**ADDENDUM NO. 1**

Plans and Specifications for: **Walnut Street Reconstruction – 2<sup>nd</sup> Street to 4<sup>th</sup> Street**

## DOCUMENT 009113 – ADDENDA 1

# PLANTER DRAIN TILE

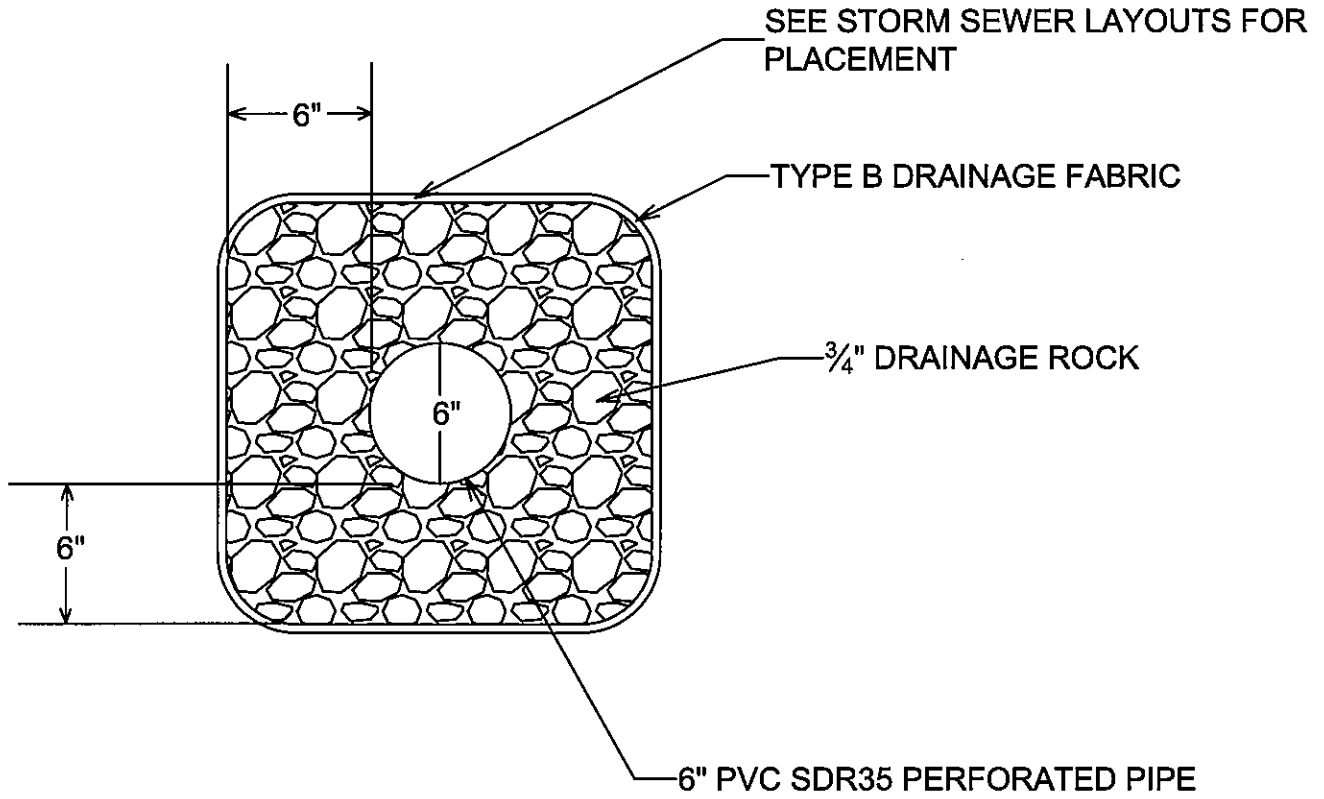
1. The attached bid form should replace the original form which was included in the specifications book. Contractor will need to utilize this form when submitting their bid. The items that have changed include:
  - 1520 feet, of 6" drain tile, has been added. See the detail included in this packet.
  - All bid items, for 20" water main, have been removed. The connection, at 2<sup>nd</sup> and Walnut, will be made north of the existing 20"x 6" tee, thusly eliminating the need for 20" pipe or appurtenances.
  - There were changes to the quantities for 6"x 45-degree bend, quartzite pavers, concrete planter, weed barrier fabric and 3" depth shredded bark mulch.
2. The attached document 009113 and the note, plan and details sheets, address changes in the landscape portion of the plans. The quantity changes referenced in these attachments, have already been adjusted on the included bid form.

L2.01

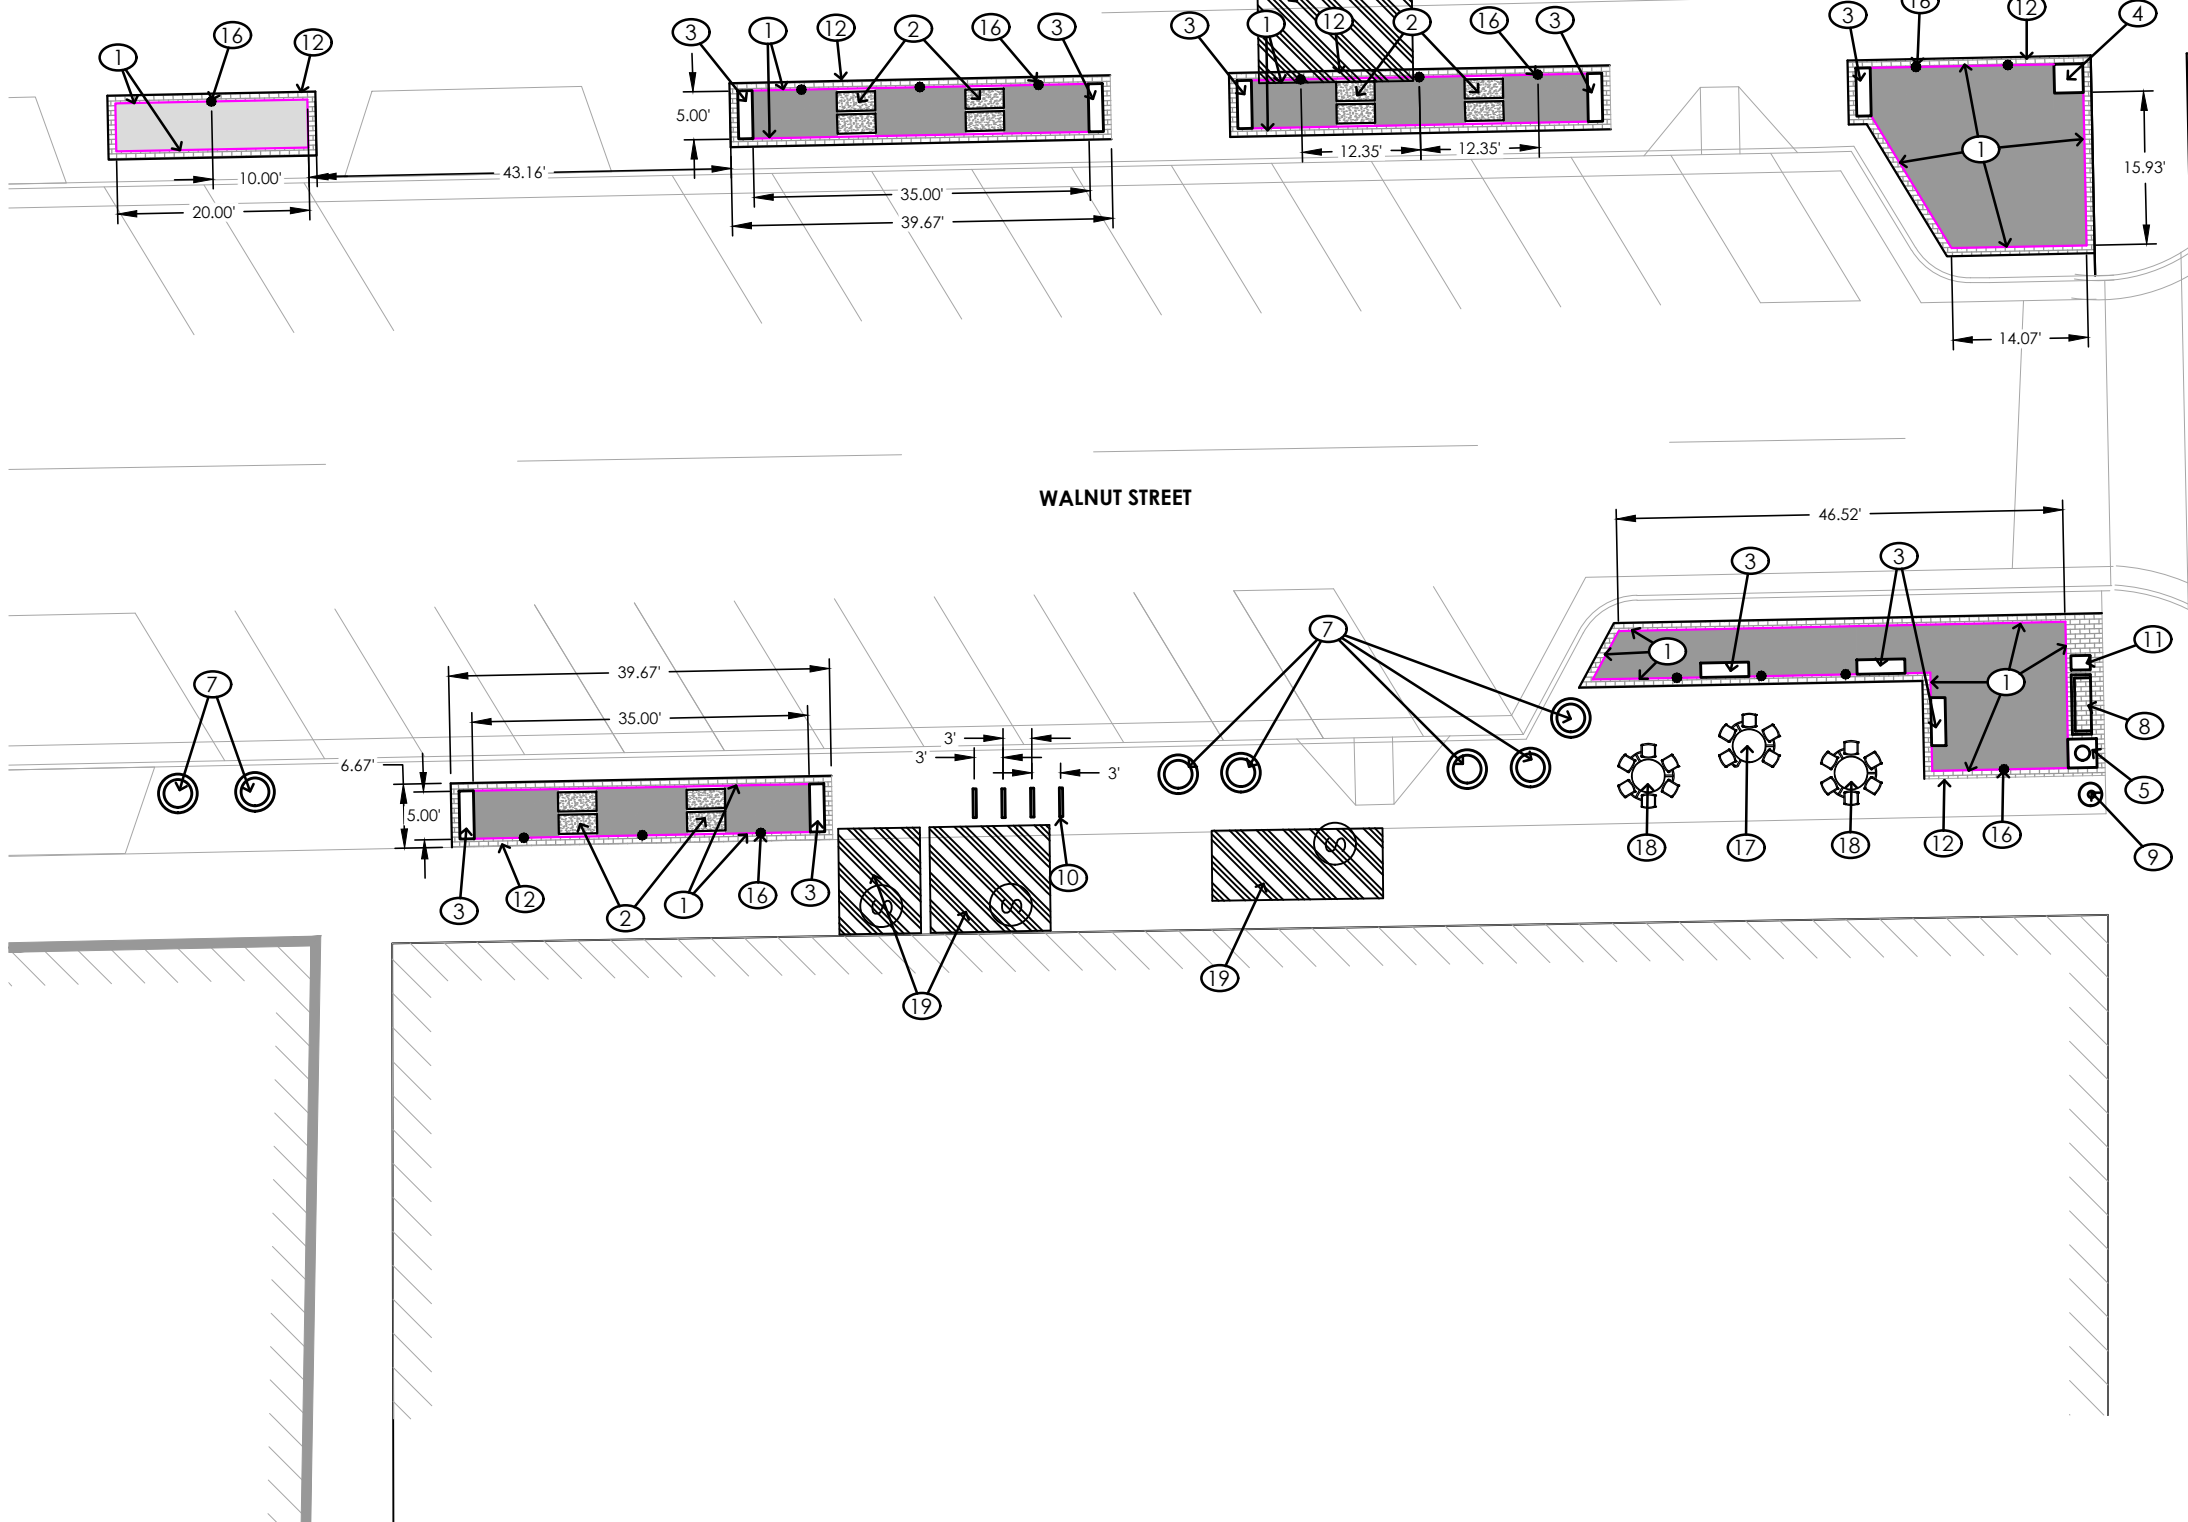
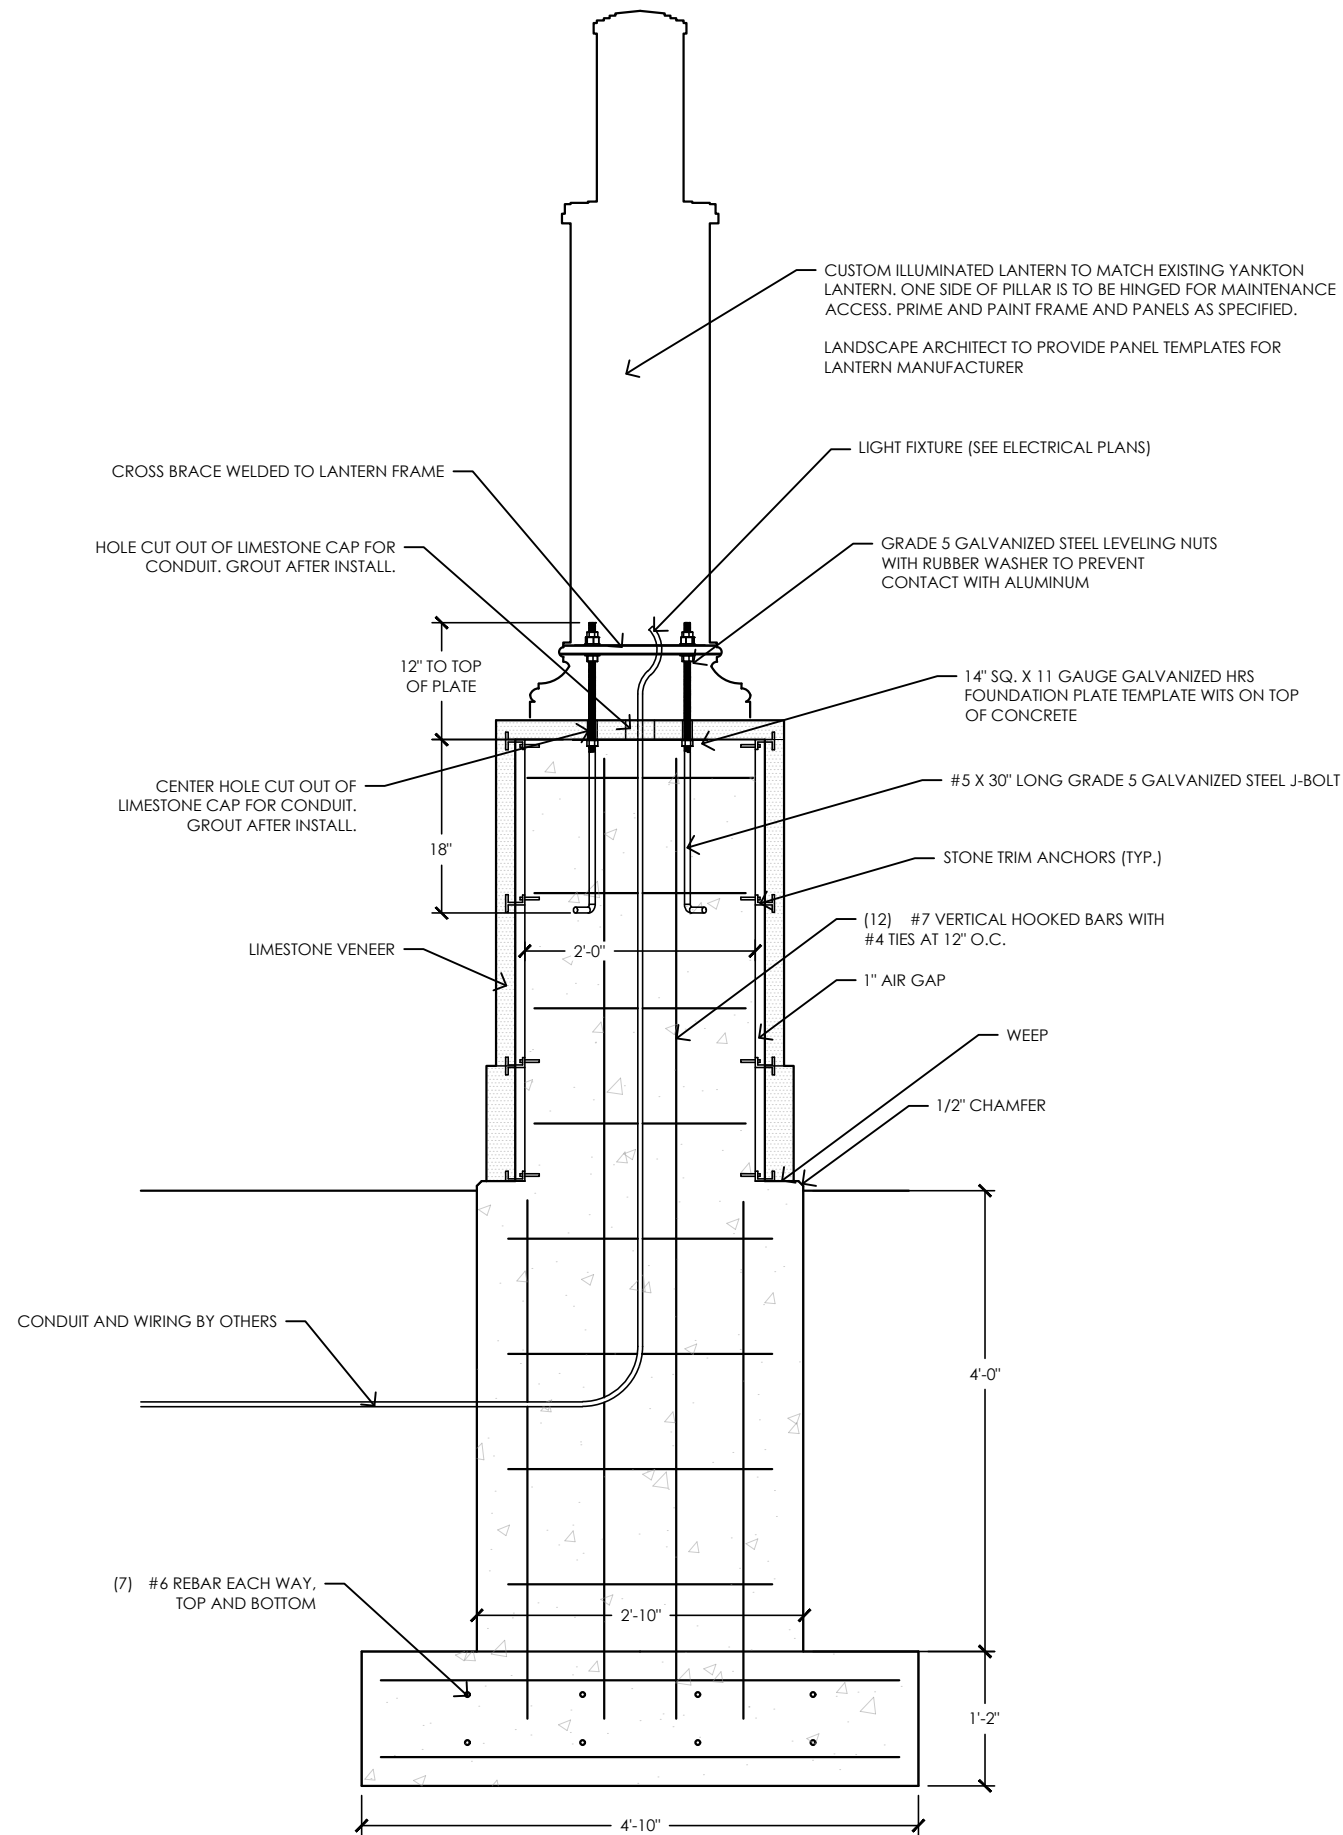
- a. Added quartzite pavers around north end of lantern at 3<sup>rd</sup> Street intersection. Paver area and corten steel edging were modified in this area.

**L4.04**

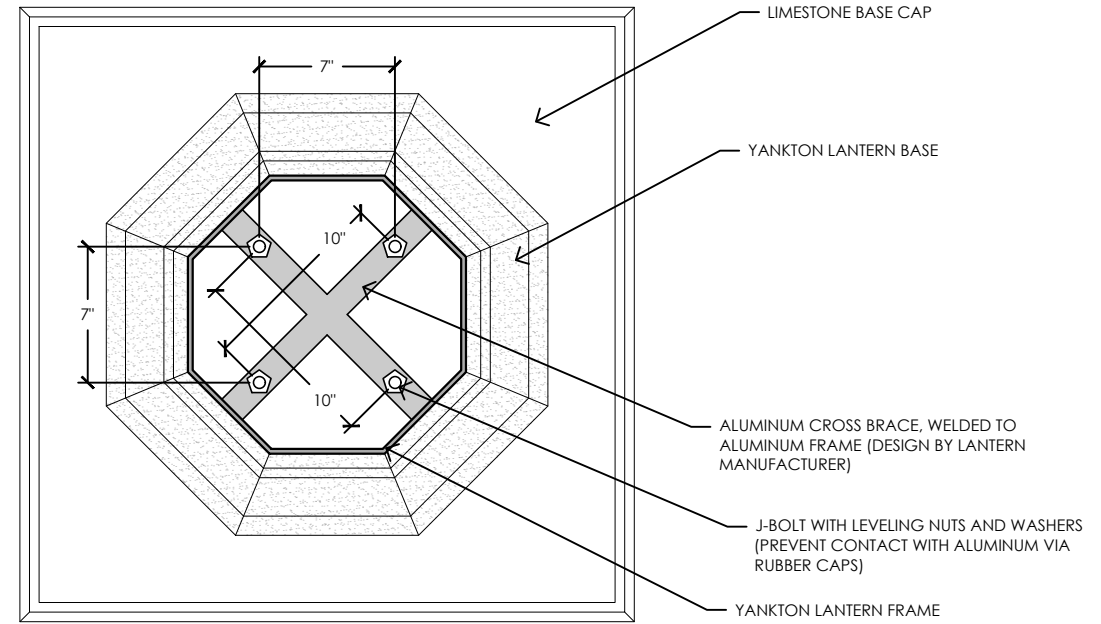
5. Landscape Details Sheet L4.04, dated March 23, 2018, reissued.
    - a. Updated lantern detail stone attachments.
  6. Landscape Details Sheet L4.06, dated March 23, 2018, reissued.
